# DEVELOPMENT REVIEW BOARD REPORT

**Mountain View  
Shopping Center -  
Exterior Remodel  
22-DR-2023**

Request for approval of exterior building modifications to an existing shopping center, including the removal of the existing arcade and changes to roofing material and paint for a +/- 7.6-acre site.

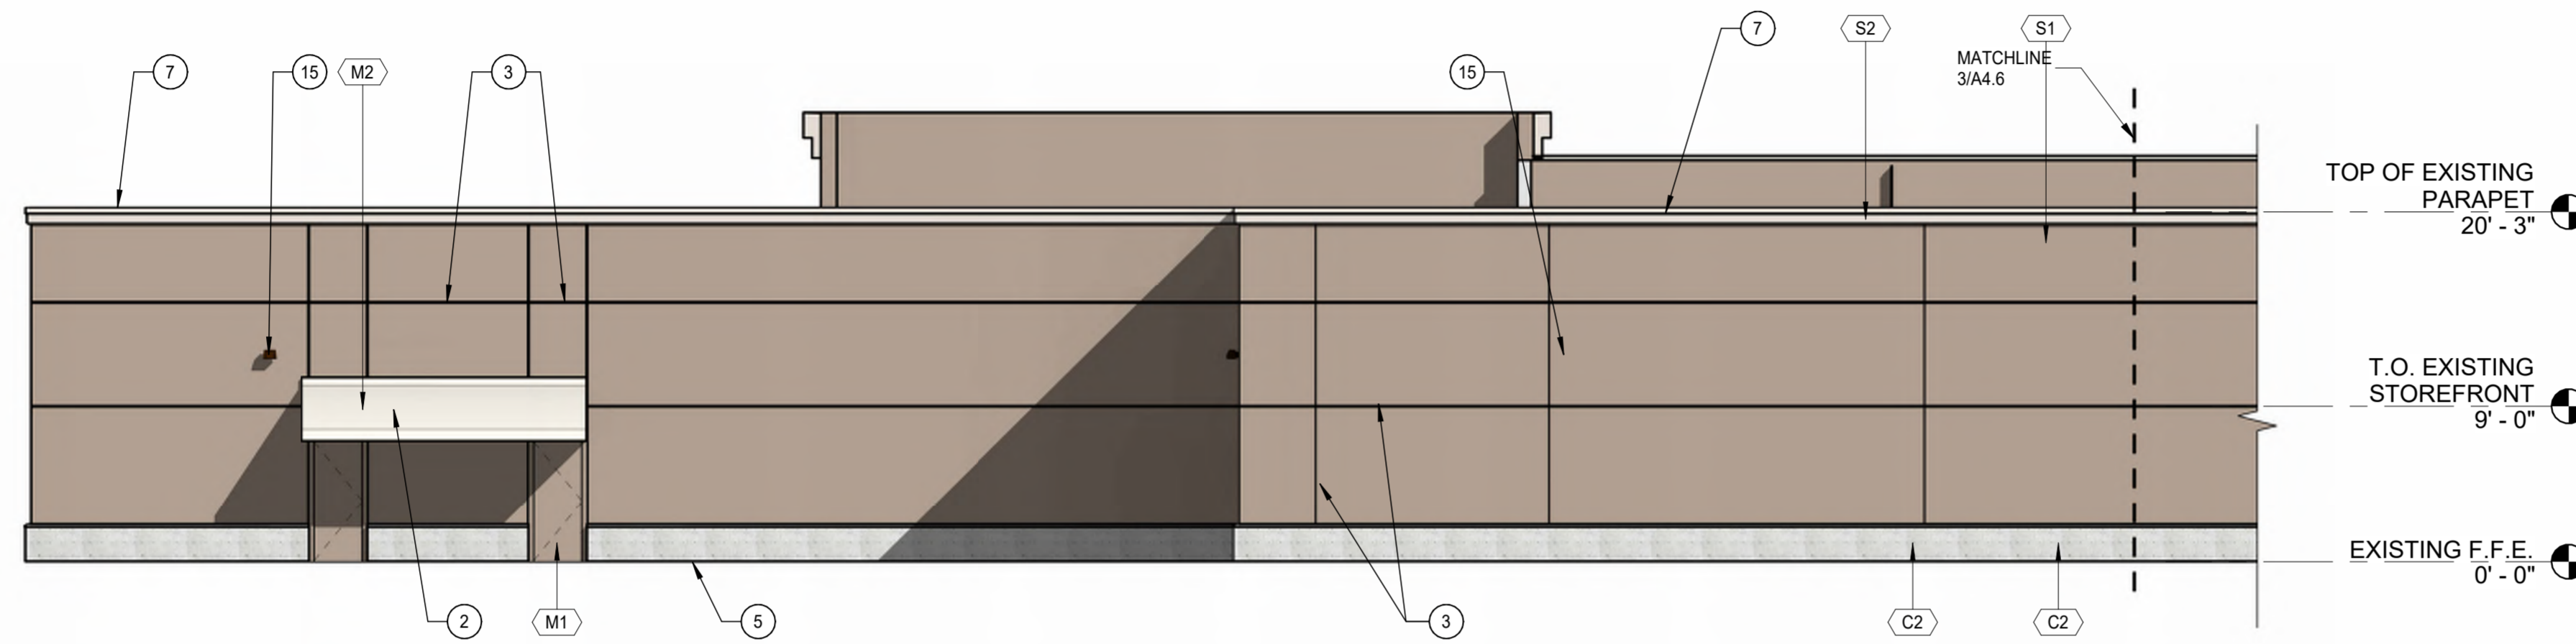
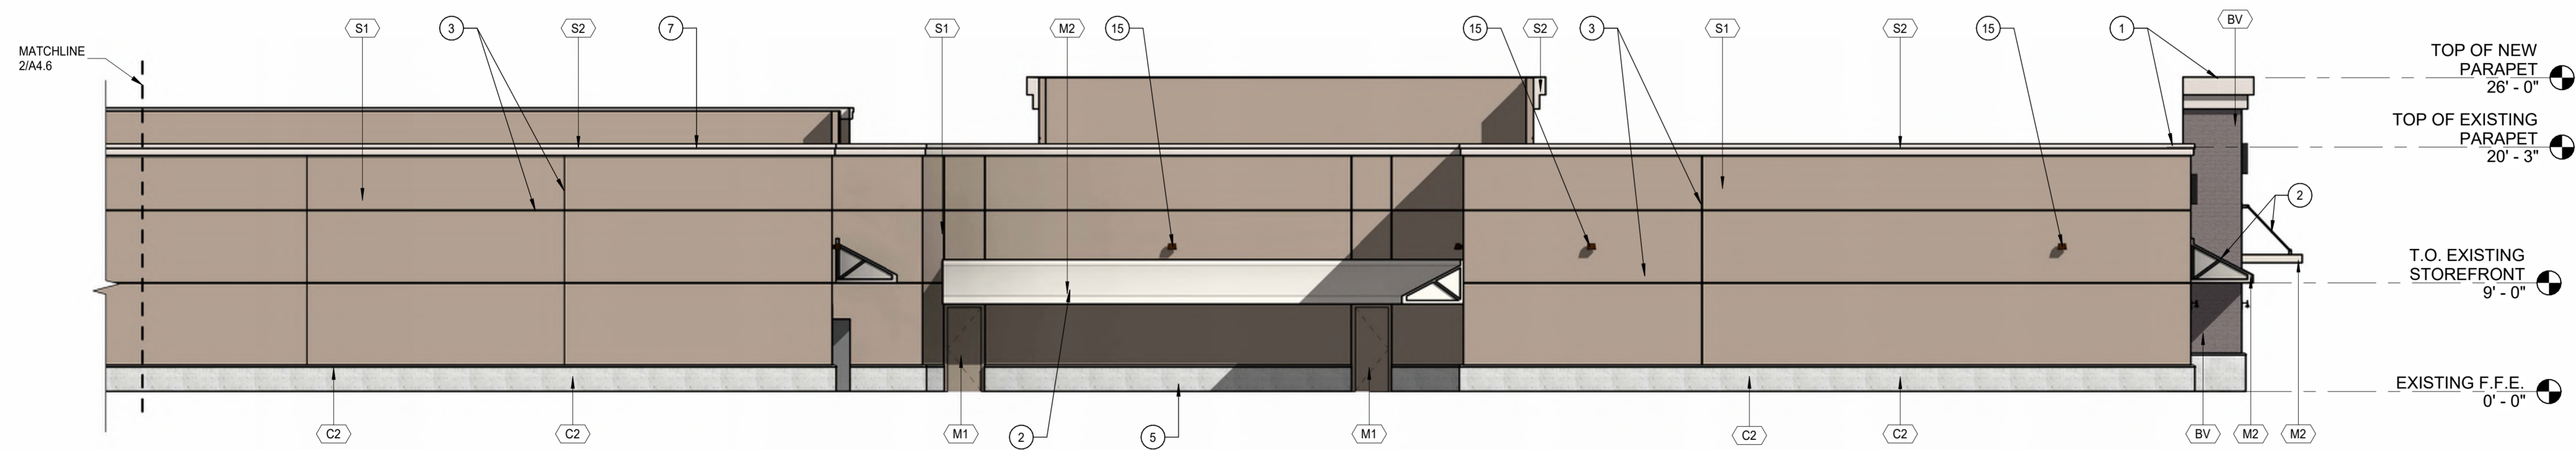
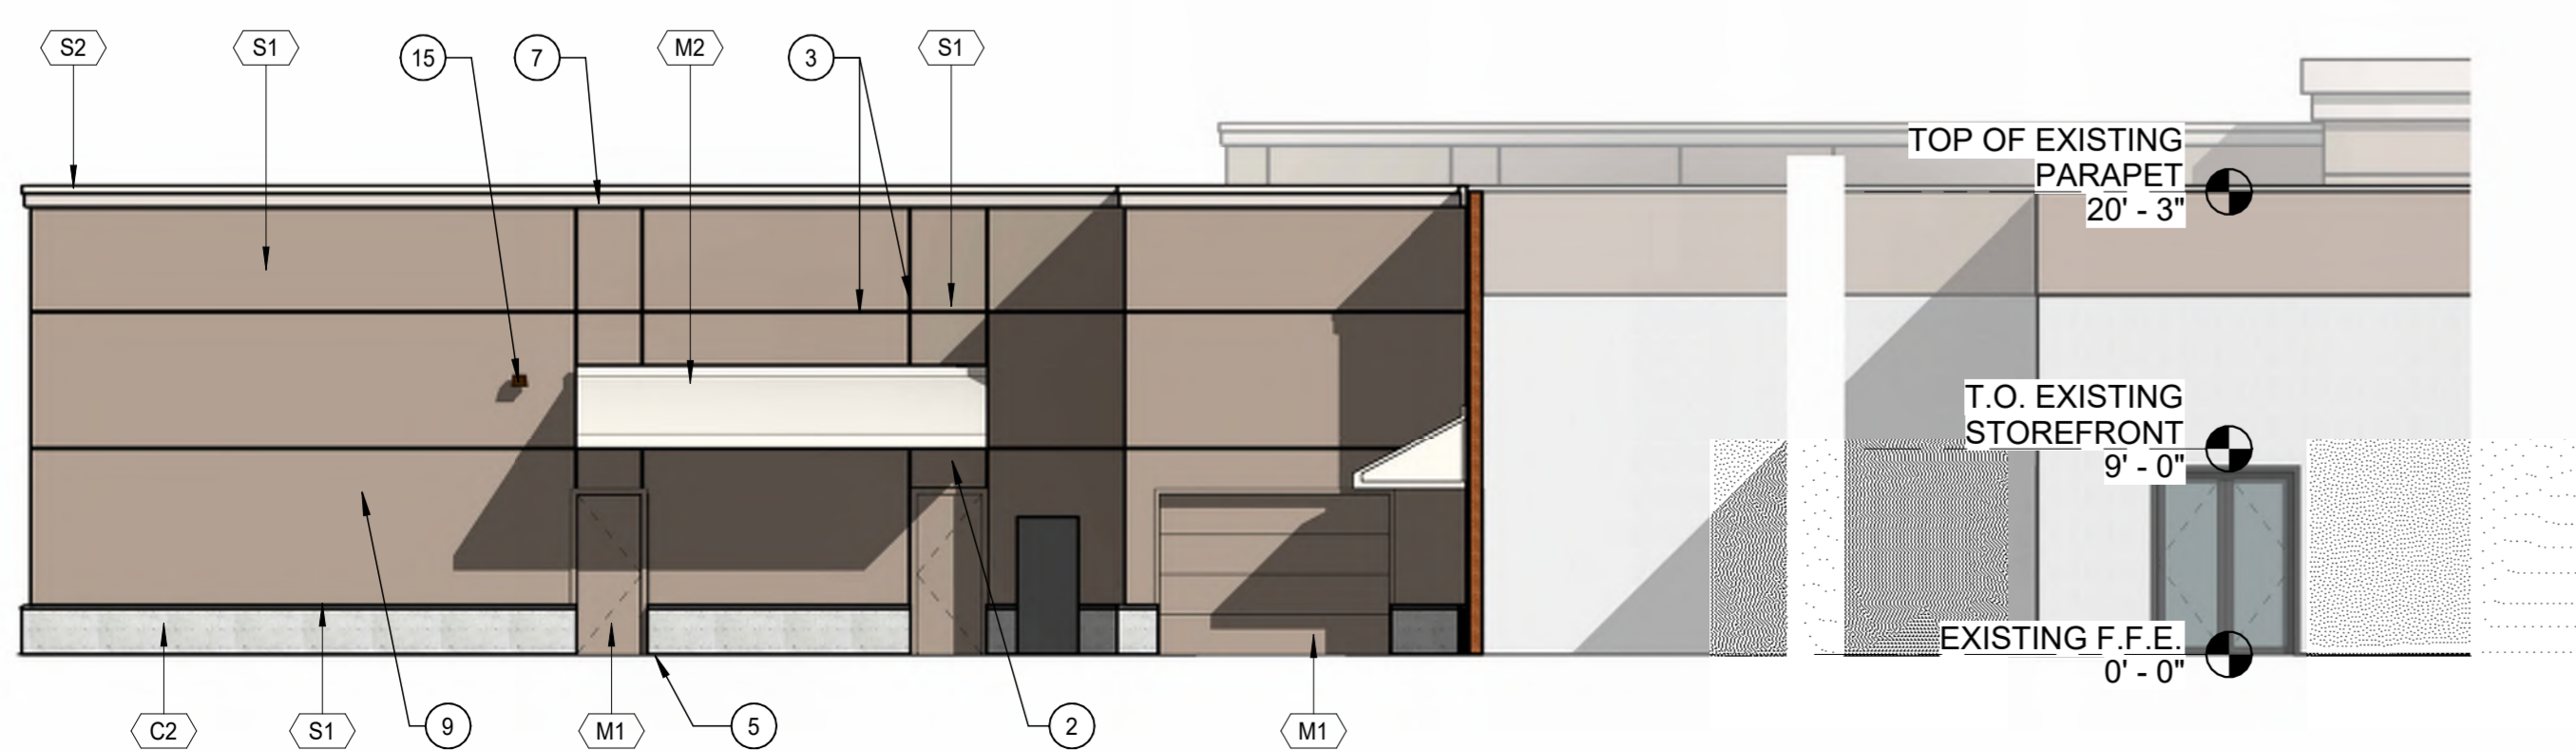
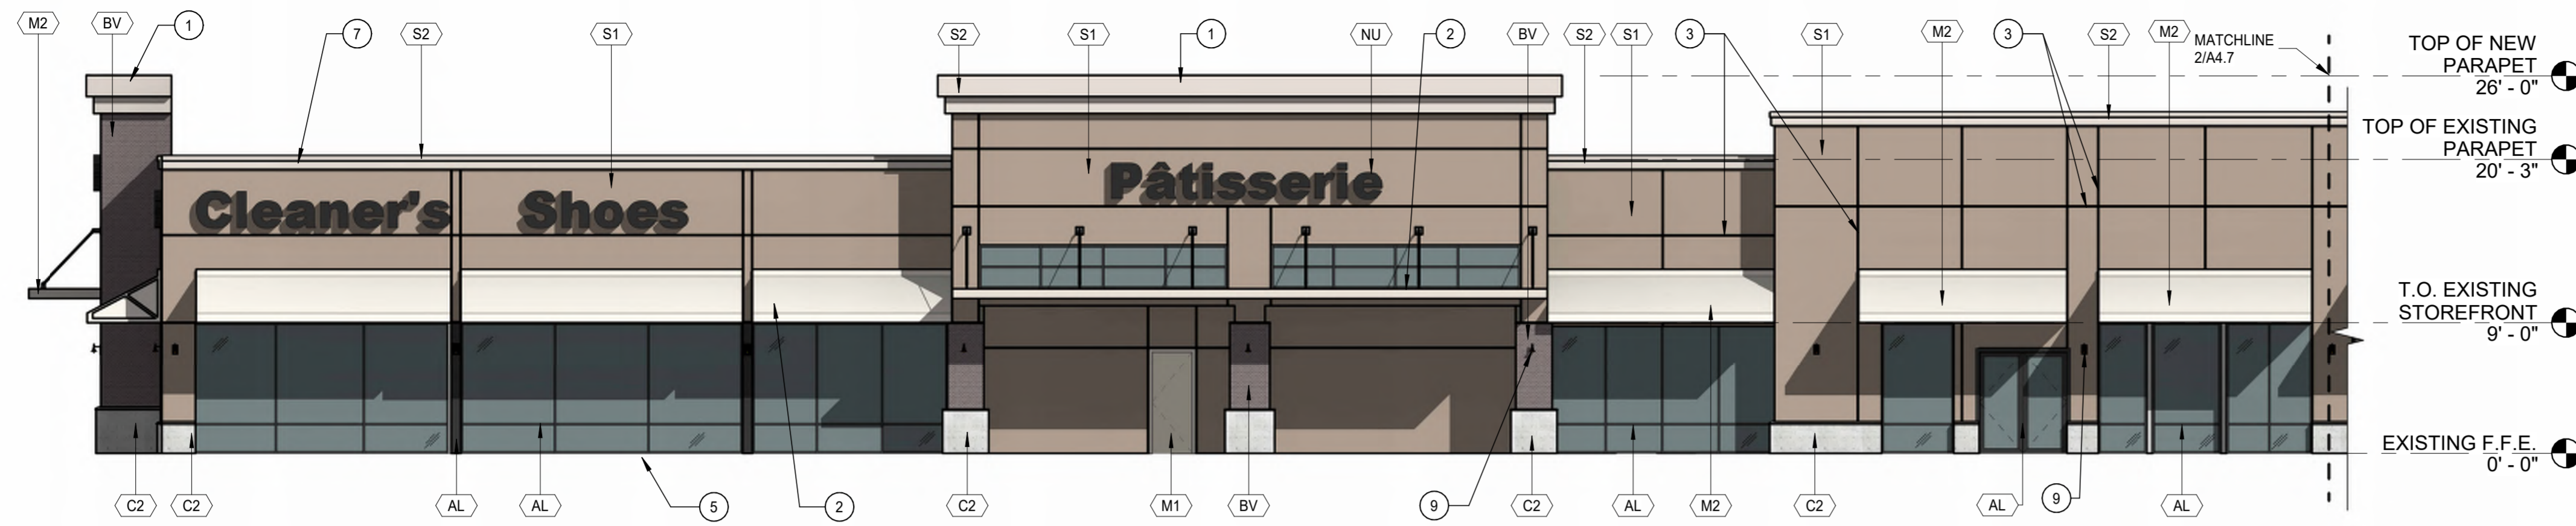
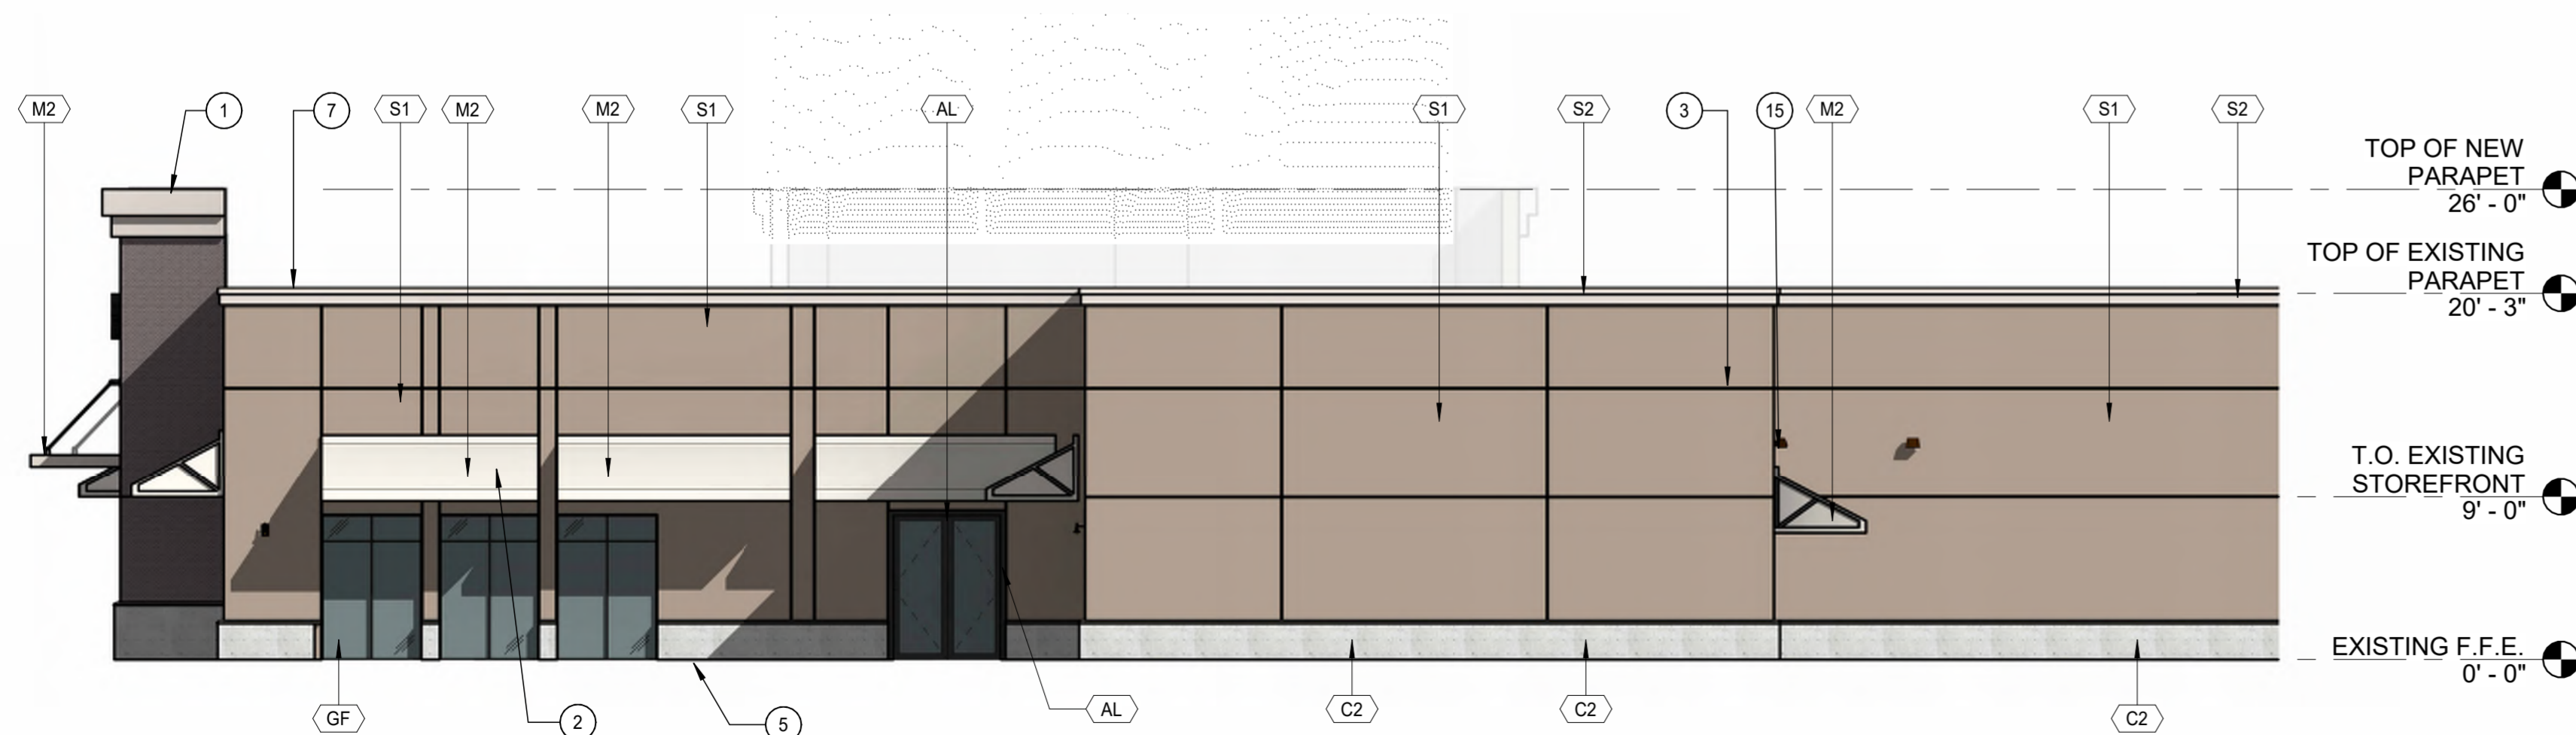
6. The concrete wainscot shall be extended to completely wrap all columns.
7. At time of final plans, the applicant shall submit updated elevations of all building facades to updated call out C2 as it does not exist. It should be C1.
